Subject: Duke Energy Carolinas, LLC
William States Lee III Nuclear Station - Docket Nos. 52-018 and 52-019
AP1000 Combined License Application for the
William States Lee III Nuclear Station Units 1 and 2
Response to Request for Additional Information
(RAI No. 2686)
Ltr# WLG2009.11-05

Lee Nuclear Station Response to Request for Additional Information (RAI)

RAI Letter No. 073

NRC Technical Review Branch: Hydrology

FIGURE 1

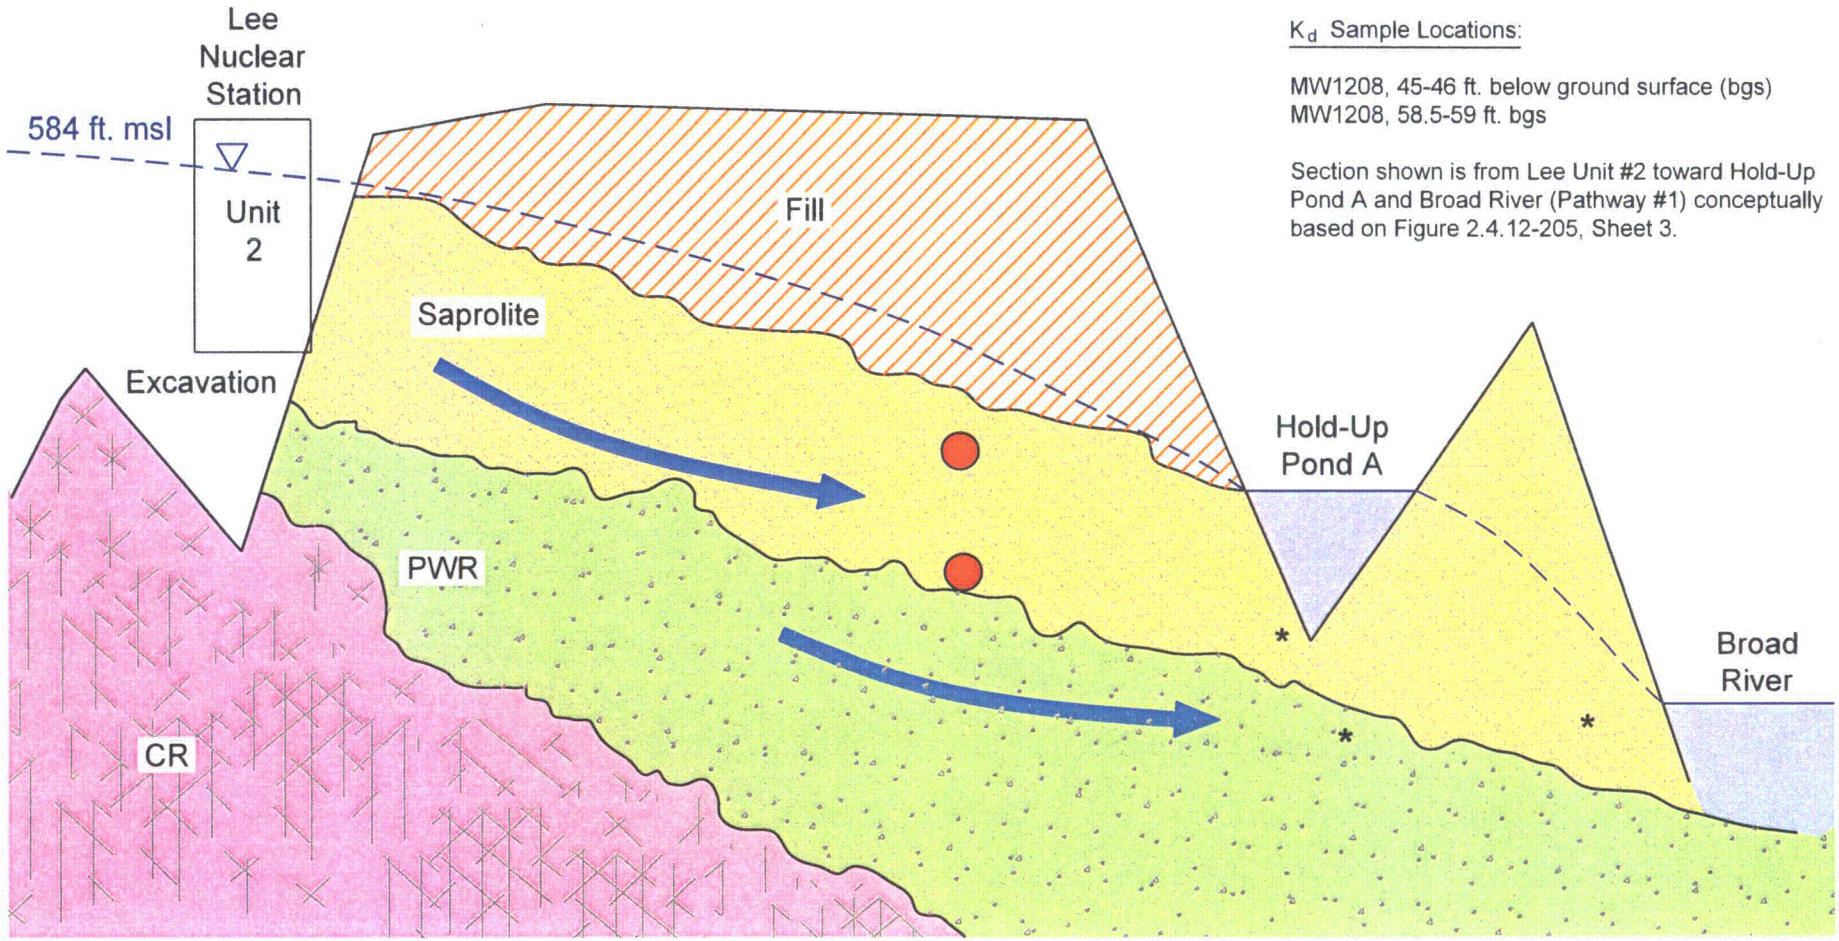
In its review of FSAR Section 2.4.13, the staff noted that there were no measurements of K_d for the PWR material, which is the material considered in the most conservative pathway. Because K_d values are important to the transport of retarded contaminants, the applicant should use K_d values for the PWR material that are measured on site samples or justify why the existing values are conservative.

Associated with this re-examination of boring logs, the general elevation of the saprolite-PWR interface in the immediate area of the Unit 2 to Hold-Up Pond A flow path was reassessed and is now interpreted to be at a higher elevation. The conceptual model of site aquifer conditions and lithostratigraphy (Figure 1, Attachment 1 to this response) reflects the results of that reassessment. This figure also depicts the locations of the two geo-media samples collected from

In the absence of K_d data specific to PWR, samples were collected and the K_d values were determined based on saprolite, as representative and characteristic of aquifer materials. As a conservative measure, for those radionuclides evaluated for K_d, the RESRAD-OFFSITE analysis used the lowest measured K_d values (i.e., the lowest measured value for each radionuclide from the three samples). All other radionuclides used the conservative K_d value of zero. Duke has concluded that, given the wide range of hydrogeological characteristics exhibited within the Piedmont Aquifer at this site, the samples collected from the site and analyzed for K_d are representative and appropriate for the accidental release analysis.

MW-1208 for site-specific K_d analysis. FSAR Figure 2.4.12-205 will be updated in a future revision of the FSAR.
